USB 3.0 ENGINEERING CHANGE NOTICE

ECR# 004

Title: Clarification on the Chamfer on USB 3.0 Micro Connectors Applied to: USB3.0 Specification Revision 1.0 (November 12, 2008)

Figure 5-12. USB 3.0 Micro-B and-AB Receptacles Interface Dimensions

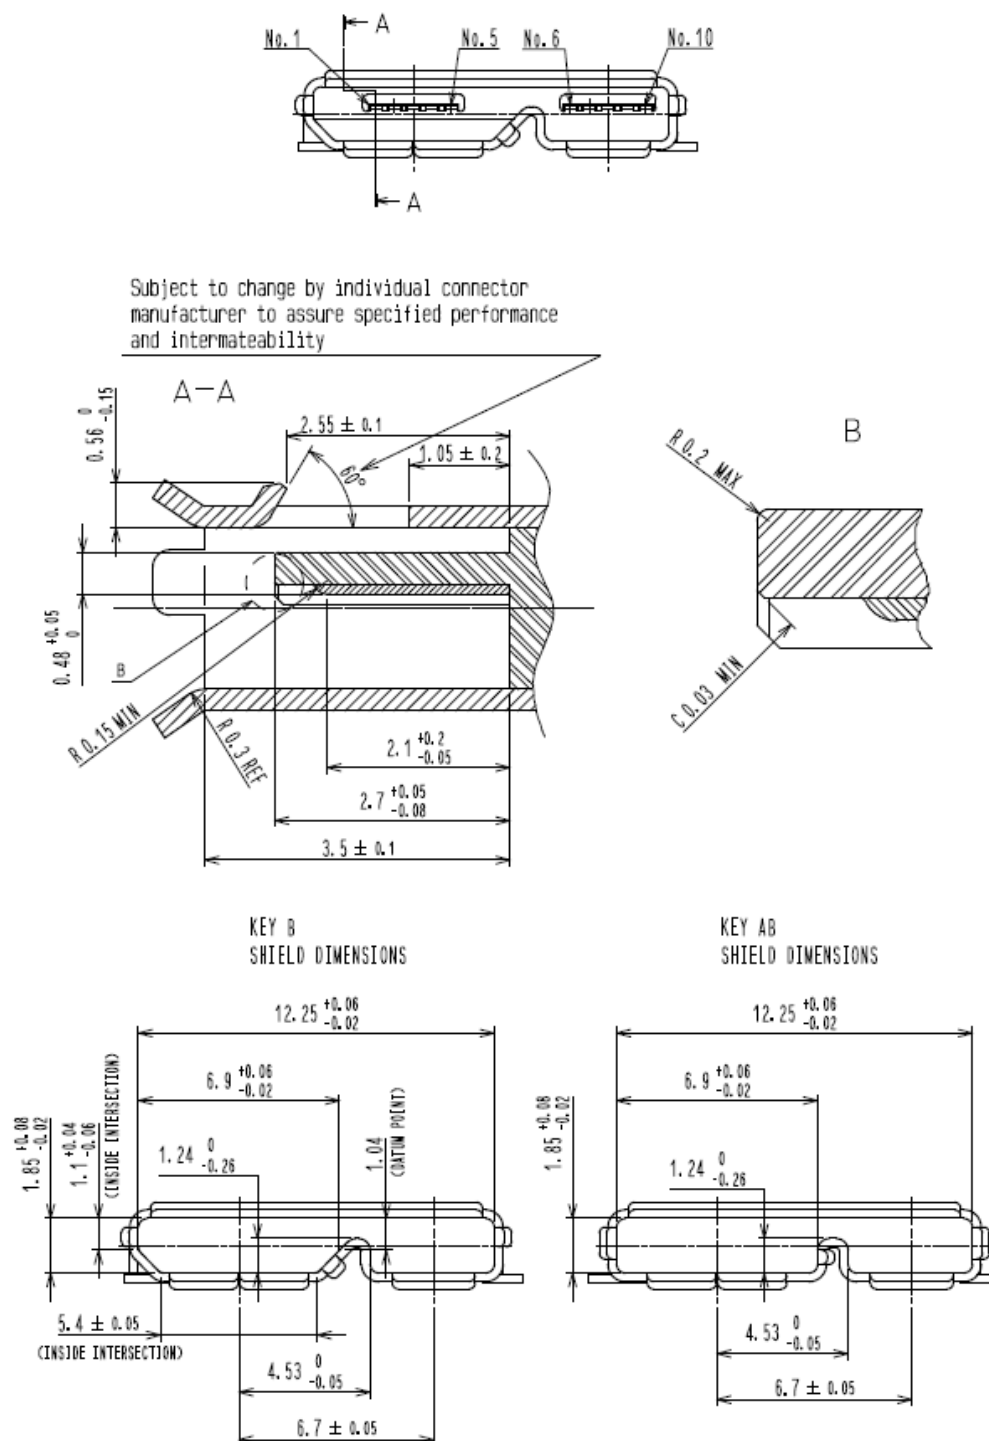
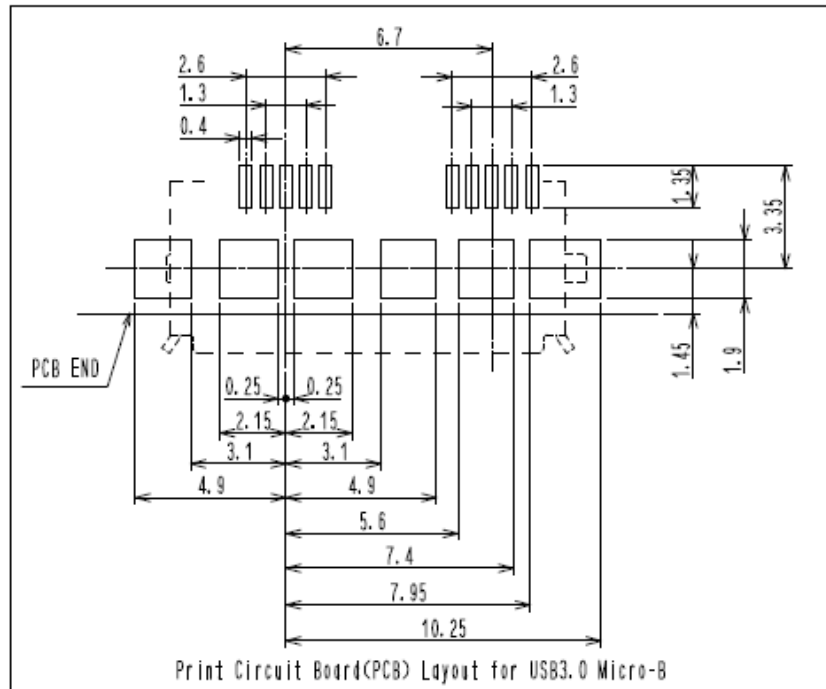
NOTES : Chamfer metals are optional. with no sharp edges.

Figure 5-14. Reference Footprint for the USB 3.0 Micro-B or -AB Receptacle

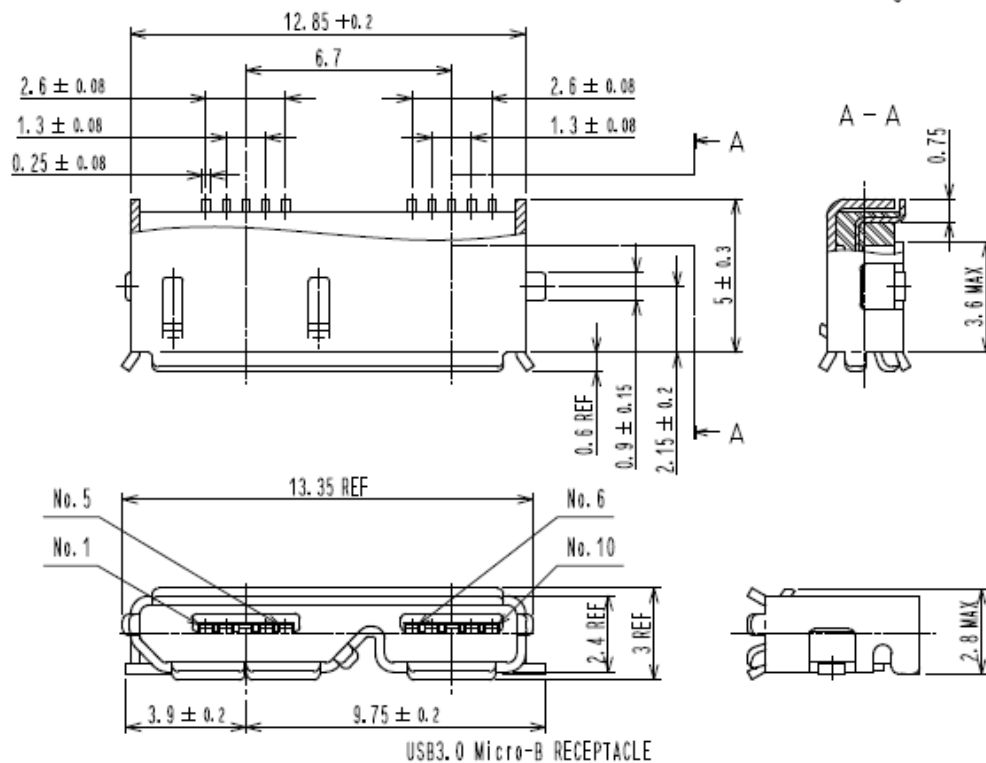
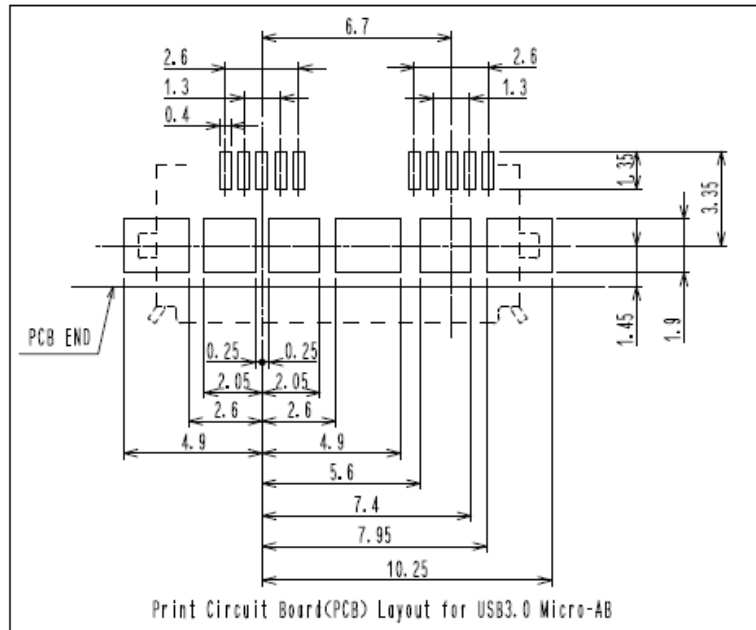
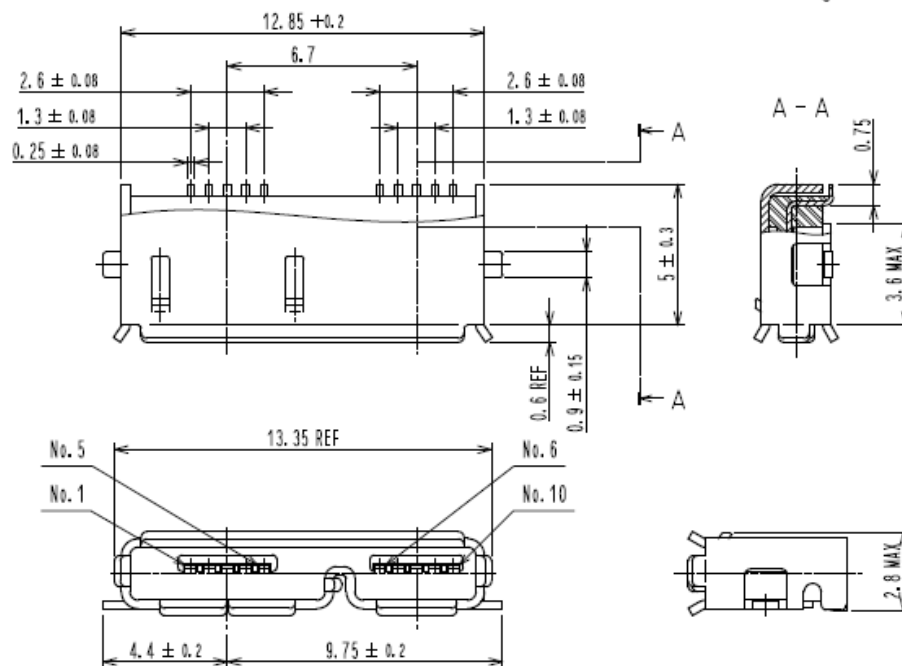
1. Critical Dimensions are TOLERANCED and should not be deviated.
2. Dimensions that labeled REF are typical dimensions and may vary from manufacturer to manufacturer.
3. General tolerance is ± 0.05 mm, otherwise the specified tolerances apply.
4. Chamfer metals are optional, **with no sharp edges.**

1. Critical Dimensions are TOLERANCED and should not be deviated.
2. Dimensions that labeled REF are typical dimensions and may vary from manufacturer to manufacturer.
3. General tolerance is +/- 0.05 mm, otherwise the specified tolerances apply.
4. Chamfer metals are optional, **with no sharp edges.**
